Gatacre Avenue- Lane Cove		Approved DA 35/2024	Proposed S4.55
Site Area m²	2965.8		
Height Control	15m	14.990m	16.290m*
Allowable FSR	2.4:1 = 7117.92 sqm	1.69=5020 sqm	1.69=5025 sqm
Zoning	R4 - High Density Residential Flat Building		
Setbacks	Front Setback 7.5m, R4 to R2 Side Setback 6m(non habitable interface)-9m(habitable interface), R4 to R4Side Setback 3m(non habitable interface)-6m(habitable interface)

AMENDMENTS LIST

PROJECT:

DRAWING BY: GR	CHECKED BY: Checked by KA	DATE: 10/04/2025
SCALE: NTS	DRAWING NO: DA001	ISSUE: F
PROJECT NO: 2318

DRAWING TITLE:
Level 4 Floor Plan

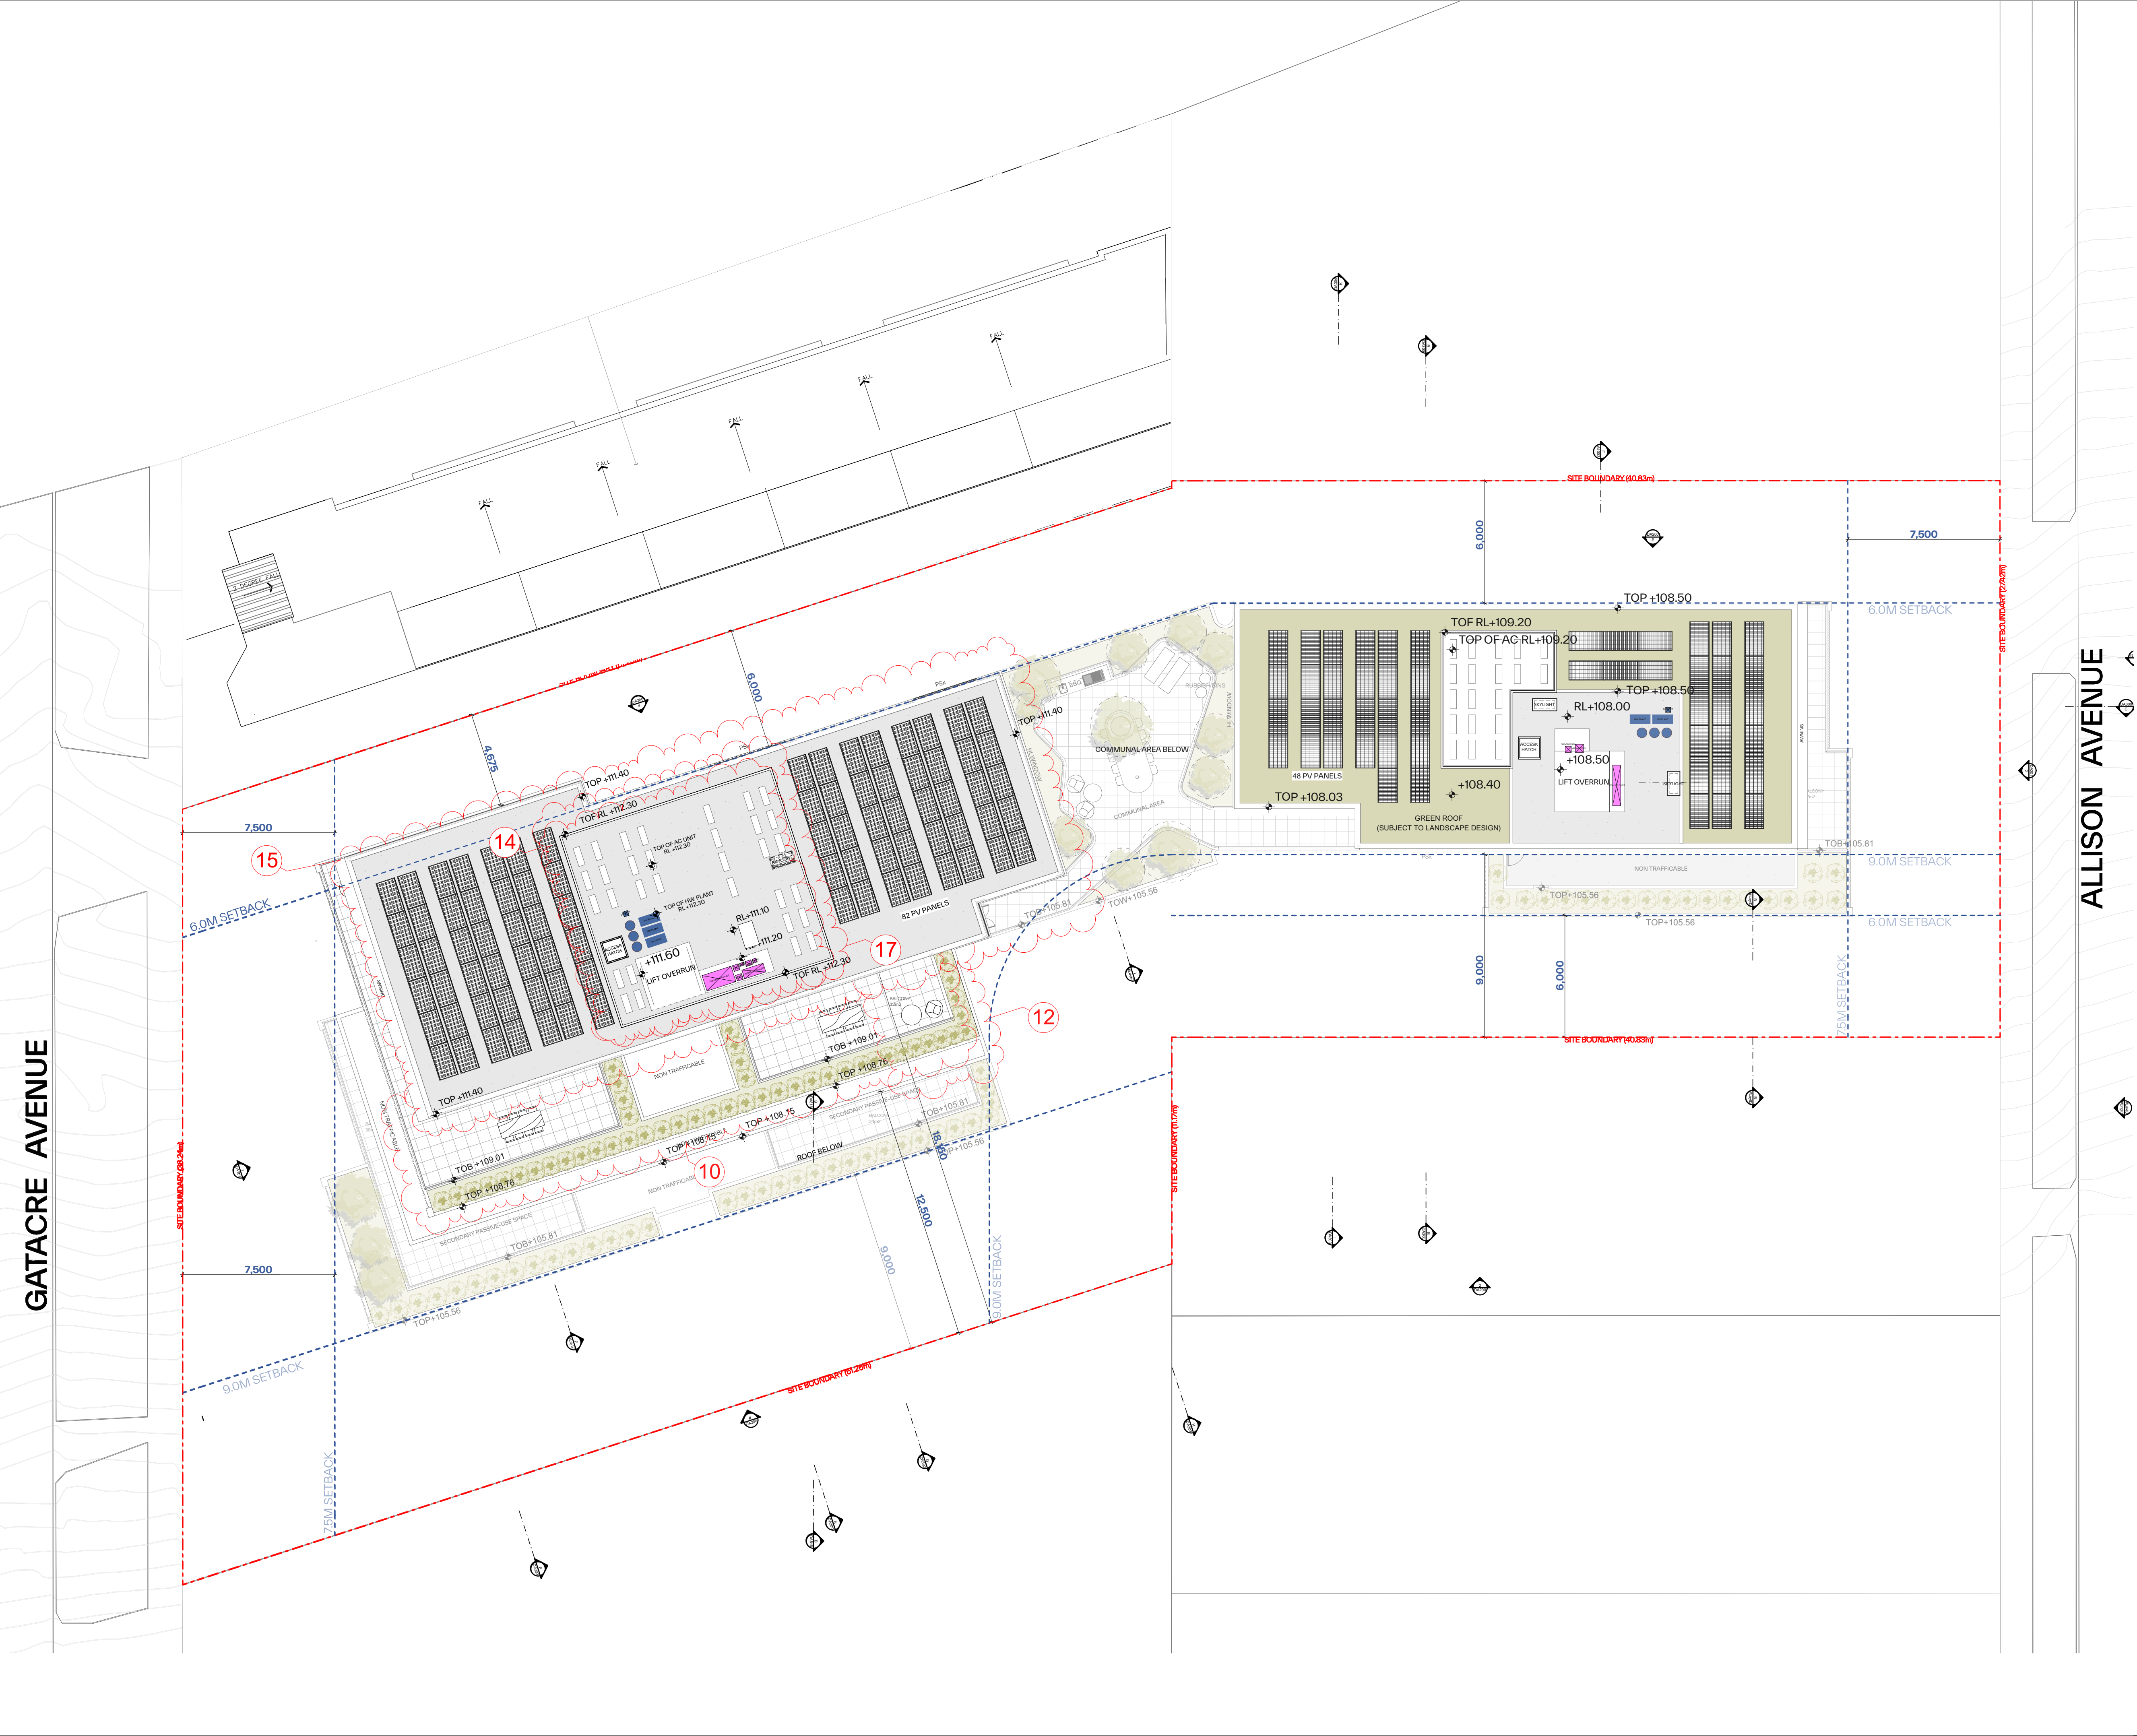
- ADDITION OF STORAGE AREA - A NEW STORAGE SPACE HAS BEEN ADDED BENEATH THE APPROVED TERRACES ON THE UPPER GROUND FLOOR
- RECONFIGURED COMMUNAL AREA - THE ENTERTAINMENT AREA HAS BEEN TRANSFORMED INTO A FITNESS SPACE, AN ACCESSIBLE RESTROOM HAS BEEN ADDED, AND THE CELLAR AREA HAS BEEN RECONFIGURED FOR IMPROVED FUNCTIONALITY

- STANDARDIZED APARTMENT LAYOUTS - INTERIOR LAYOUTS HAVE BEEN AMENDED FOR UNIFORMITY ACROSS ALL APARTMENTS
- TERRACE MODIFICATION - A PREVIOUSLY NON-TRAFFICABLE TERRACE HAS BEEN CONVERTED INTO A PRIVATE OPEN SPACE FOR UNITS 205, 302, 401 AND 402

- AMENDED ROOFTOP AREA DESIGN - THE BBQ AREA HAS BEEN REPOSITIONED FOR BETTER ACCESSIBILITY AND FUNCTIONALITY, GENERAL UTILITY SINK AND RUBBER BIN ADDED TO Z05

- INCREASED APARTMENT SIZE - UNIT 205 HAS BEEN EXPANDED
- ADDED HIGHLIGHT WINDOWS - A HIGHLIGHT WINDOW HAS BEEN ADDED TO THE WALL BETWEEN THE COMMUNAL OPEN SPACE AND UNITS 304 AND 305 TO IMPROVE SOLAR AMENITY
